Subject: Amended MHI's Response to US-APWR DCD RAI No. 107-1293 Revision 0
(SRP 03.09.04)

Amended Response to Request for Additional Information
No. 107-1293, Revision 0

RAI NO.: NO. 107-1293 REVISION 0
SRP SECTION: 03.09.04 – CONTROL ROD DRIVE SYSTEMS
APPLICATION SECTION: 3.9.4
DATE OF RAI ISSUE: 11/24/08

Figure 1 Applied Area of the Chrome Carbide Coating

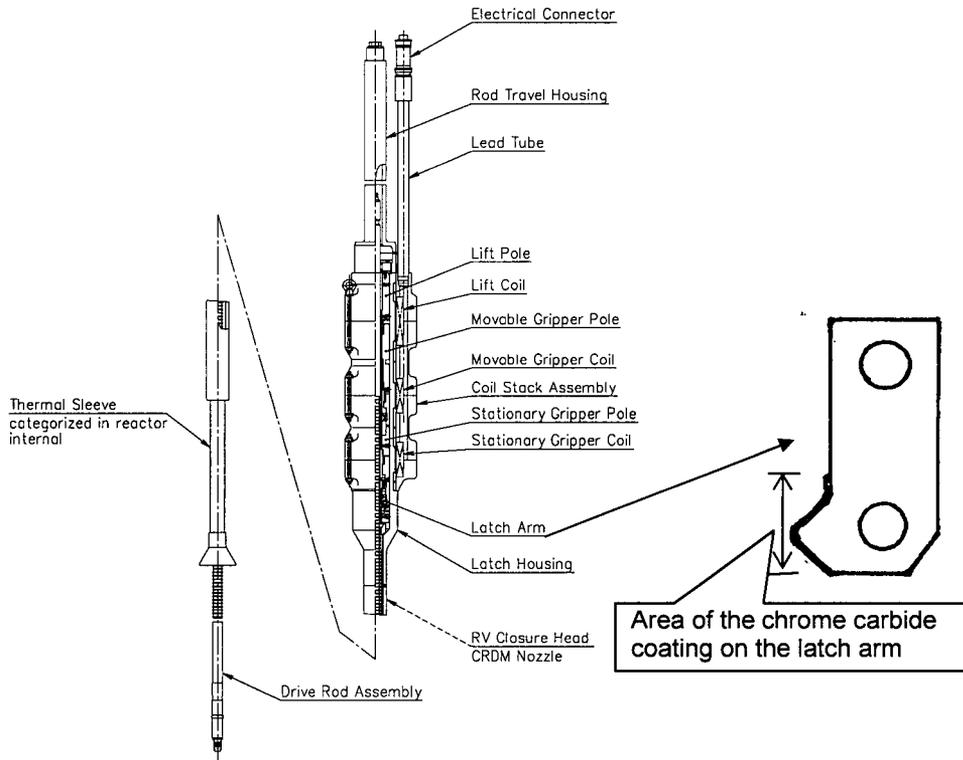
- a. Describe differences between the US-APWR and the previous design, such as the L-106A CRDM and discuss their effects on the applicability of the previous operability tests to the US-APWR CRDM. US-APWR DCD Tier 2, Section 3.9.4.1.1 (page 3.9-56) states that the US-APWR CRDM design is improved by (1) butt welding the CRDM latch housing to the CRDM nozzle on the reactor vessel closure head and (2) applying a chrome carbide coating to the latch arms.

The design of the US-APWR CRDM latch assembly is the same as the previous L-106A type CRDM, except the chrome carbide coating on the latch arms to improve wear resistance. The latch assembly is shown in Figure 1. This design change does not affect operability, since

the thickness of the chrome carbide coating is thin enough compared with the clearance between the latch tip and the groove of the drive rod.

Thickness of the chrome carbide coating on the latch arm is [] mils, which is thin enough compared with the approximately [] inch clearance between the latch tip and groove of the drive rod. Therefore, chrome carbide coating does not affect operability.
